FROST'S CORNER SUBDIVISION

APPLICATION NUMBER 4 DATE April 2, 2015

REQUEST Subdivision

DETAIL SITE PLAN

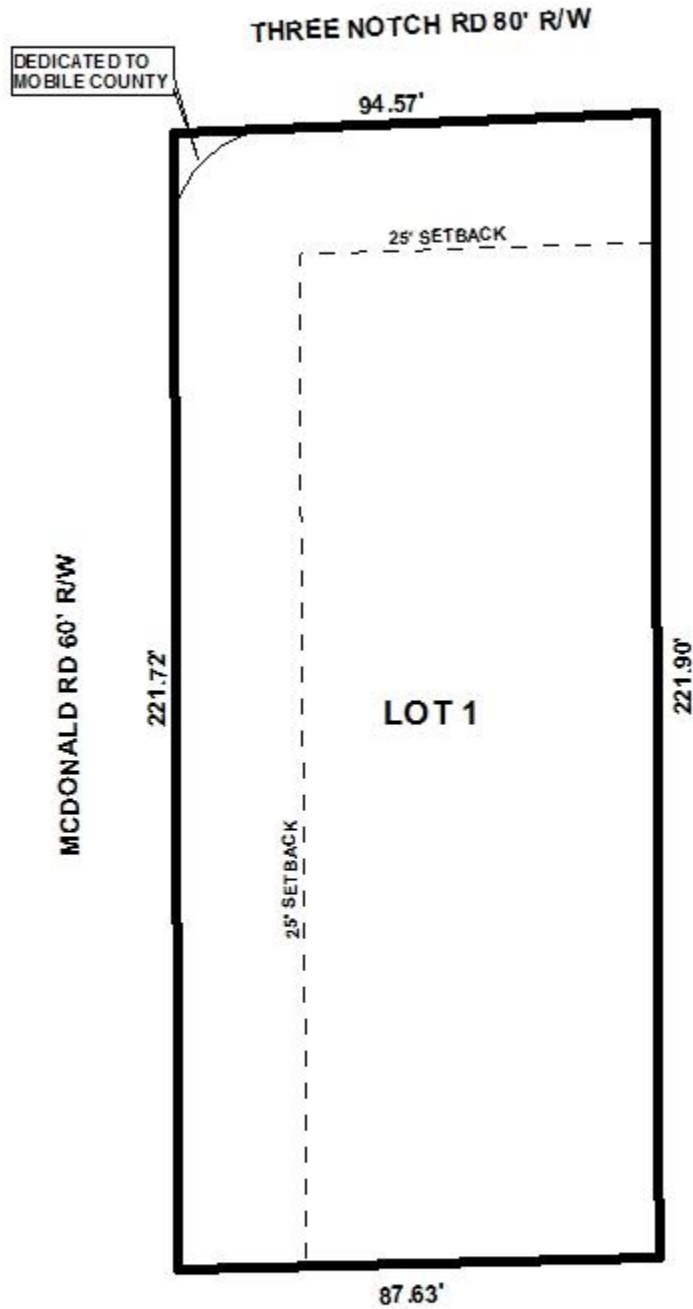
The site fronts on Three Notch Road and McDonald Road, both major streets, as illustrated on the Major Street Plan, with planned 100-foot rights-of-way. The plat depicts Three Notch Road as having an 80' right-of-way and McDonald Road as having a 60' right-of-way. Dedication to provide 50' as measured from centerline from both Three Notch Road and McDonald Road will be required.

The site is currently developed with what appears to be a vacant building, and with two existing curb-cuts. If approved, a note should be placed on the Final Plat stating the proposed lot is limited to two curb-cuts with the size, design and location of all curb-cuts to be approved by County Engineering.

The lot size is labeled in square feet and acres. It should be noted however that the properties to both the East and West of the site have been required to provided dedication, as well as properties to the North, across Three Notch Road. Therefore, if approved, the lot size in square feet and acres should be revised on the Final Plat, or the furnishing of a table providing revised information will be required.

The 25' minimum building setback line is depicted on the plat. However, revisions along Three Notch Road and McDonald Road due to dedication should be made and the illustration of new 25-foot minimum building setback lines should be depicted on the Final Plat.

A corner radius in compliance with Section V.D.6. of the Subdivision Regulations is depicted on the preliminary plat and should be revised to correspond with the Major Street dedications on the Final Plat.

- 1) dedication sufficient to provide 50' from the centerline of McDonald Road;
- 2) dedication sufficient to provide 50' from centerline of Three Notch Road;

- 3) revision of the 25-foot minimum building setback line to reflect dedication;
- 4) revision of the lot size in square feet and acres to reflect dedication;

- 5) placement of a note on the Final Plat stating the lot is limited to two curb-cuts with the size, design and location of all curb-cuts to be approved by County Engineering;

- 8) revision of the corner radius to correspond with the Major Street dedications on the Final Plat;
- 9) placement of a note on the plat stating that the development will be designed to comply with the storm water detention and drainage facility requirements of the City of Mobile storm water and flood control ordinances, and requiring submission of certification from a licensed engineer certifying that the design complies with the storm water detention and drainage facility requirements of the City of Mobile storm water and flood control ordinances prior to the issuance of any permits. Certification is to be submitted to the Planning Section of Urban Development and County Engineering.
